Subject: Docket No. 50-206
Masonry Wall Evaluations
SEP Topic III-6
Seismic Design Considerations
San Onofre Nuclear Generating Station
Unit 1

SAN ONOFRE NUCLEAR GENERATING STATION, UNIT 1

MASONRY WALL EVALUATION

RESPONSE TO ITEMS RAISED AT MEETING OF MAY 11-13, 1982

FIGURE 4.1

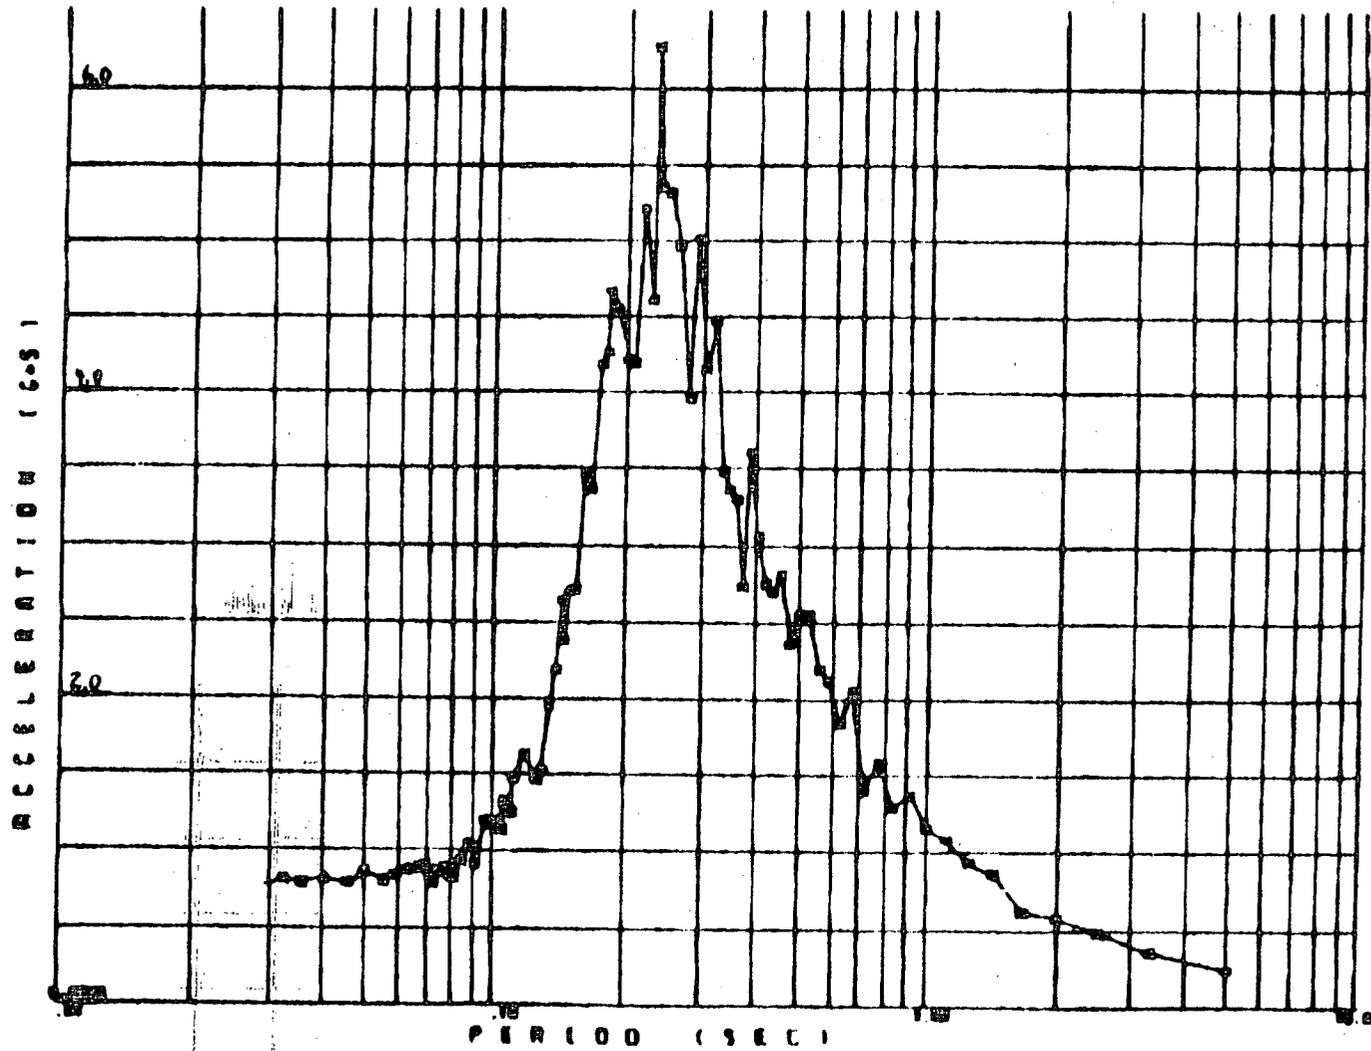
4. Item

Demonstrate that the representation of the Turbine Building Extensions as single-degree-of-freedom oscillators is appropriate.

Of the four Turbine Building extensions only the North Extension is not connected to the top of the masonry enclosure wall. The East and West Heater Platforms are symmetric and their seismic response is therefore essentially the same. Therefore, examination of the responses of only the West Heater Platform and the South Extension is sufficient to assess the adequacy of the single-degree-of-freedom representation of these structures in the nonlinear masonry wall analysis.

The instructure response spectra (IRS) for the two horizontal directions in the West Heater Platform and the South Turbine Building Extension are presented in Figures 4.1 through 4.4. As can be seen by these figures, with the exception of the East-West motion in the South Extension all the IRS show only one predominant peak. Detailed evaluation revealed that the two peaks shown in Figure 4.3 are completely decoupled. In this single case the input into the masonry walls would be due to two distinct modes. However, the masonry walls in the South Extension have frequencies based on the cracked section of approximately 1 Hertz. Of the two peaks the low frequency peak at approximately 3 Hertz is of more consequence than the peak at approximately 9 Hertz since its amplification effects are not fully dissipated at the frequency associated with the masonry wall (see Figure 4.3). Therefore, the low frequency single degree of freedom representation of the South Extension was utilized in the analysis. It should also be noted that in all cases the dominant modes associated with the peaks have at least 15% damping due to soil-structure interaction. The single degree of freedom oscillator utilized in the masonry wall analysis was in all cases assigned 7% damping. This indicates that the idealized representation of the Turbine Building incorporated in the analysis would yield significantly more amplification than would occur with a more detailed representation.
